# The Northwood Action Group Inc

### RE : Submission to IPC – including reference to DPIE’s assessment report and Applicant’s Response to submissions and suggested “continuum of care” model

**Proposal Name:** *Greenwich Hospital (SSD No. 8699) at 97-115 River Road, Greenwich*

**Above: example of how the Applicant has reverse-engineered their proposal since inception**

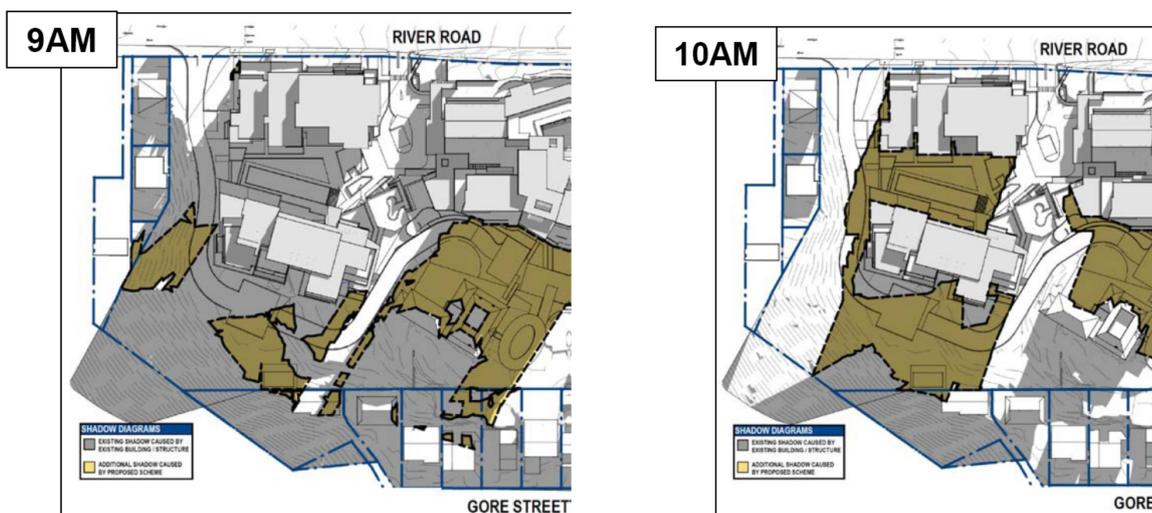
Below is an example of proposal’s reverse-engineering, wherein the Applicant has incorporated so-called “shared space” to bolster the hype of the integration of the seniors apartments. To what extent – other than for financing it – does the Hospital rely on the Seniors apartments spaces?

**Both the above shadow diagrams appear in the DPIE presentation. They are both WRONG. They cannot be right, because the contours are wrong.**

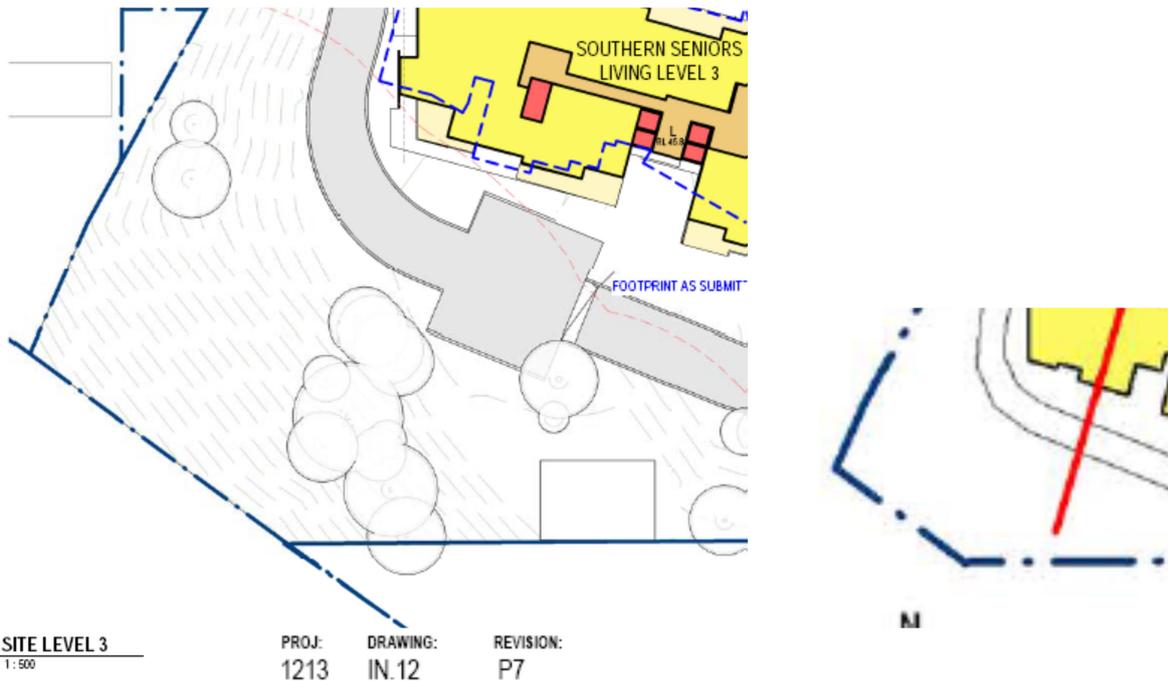
**For example,1.** see the below shadow diagrams – they are both wrong, but accepted ed by DPIE.

**Above L:** example of the incorrect contours shown by withholding survey info. **R:** red line cuts for X Sect C

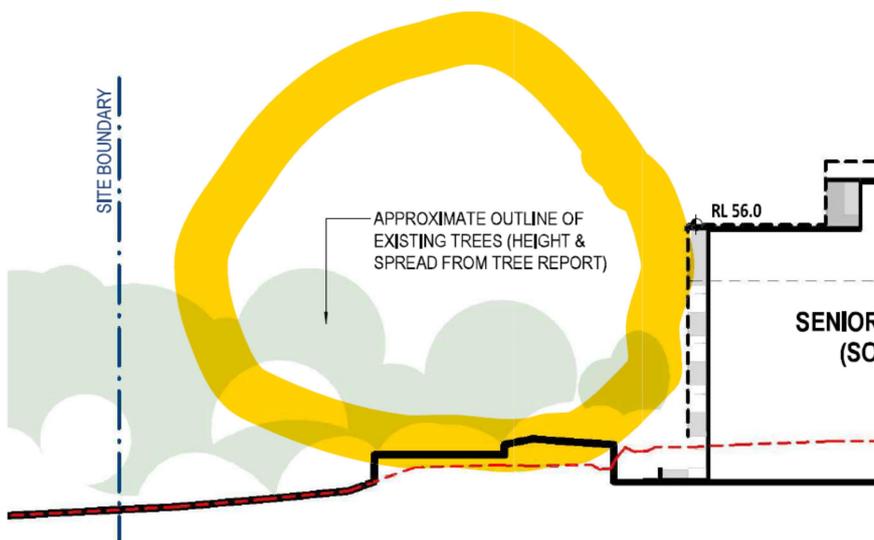
**For example,2.** see the below incorrect contour diagram with “trees” sited on wrong contours. When Cross-Section C is cut - along the red line in below right diagram – the trees in view become incorrectly depicted in the sectional elevation view, even though the text states that “height and spread from tree report”, they were not.

C CROSS SECTION - SENIORS LIVING APARTMENTS  
1:250

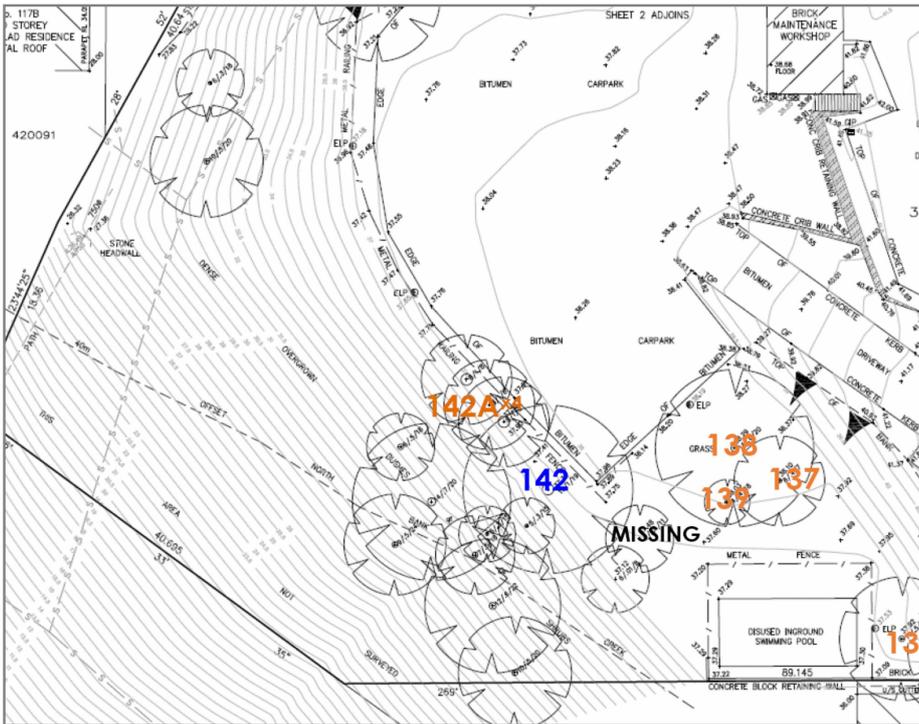
**Above** Tree canopy circled does not exist as shown in X Sect C. It misleads because, initially, the trees were not in the Arborist report, nor were contours correctly depicted from which to calculate their height.

**Above: Extract from first Redgum report had incorrect contours; excluded trees not numbered.**

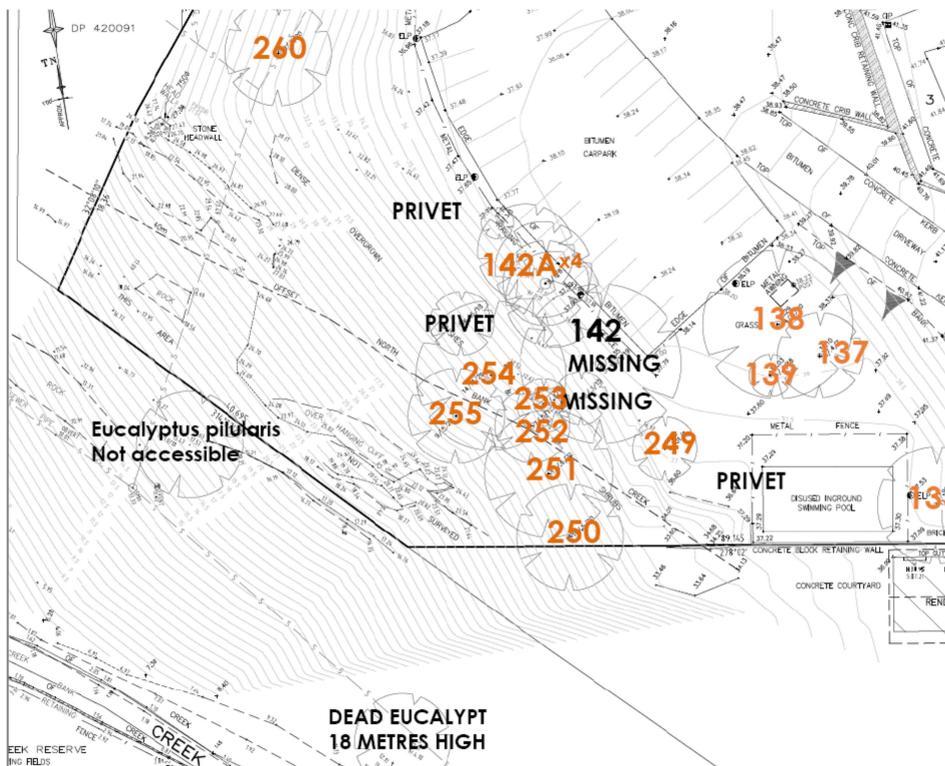
Later, the Redgum arborist report was amended to add tree numbers and selectively show portions of the rock formations but these portions did not gel with the false contours. Compare the extracts below:-
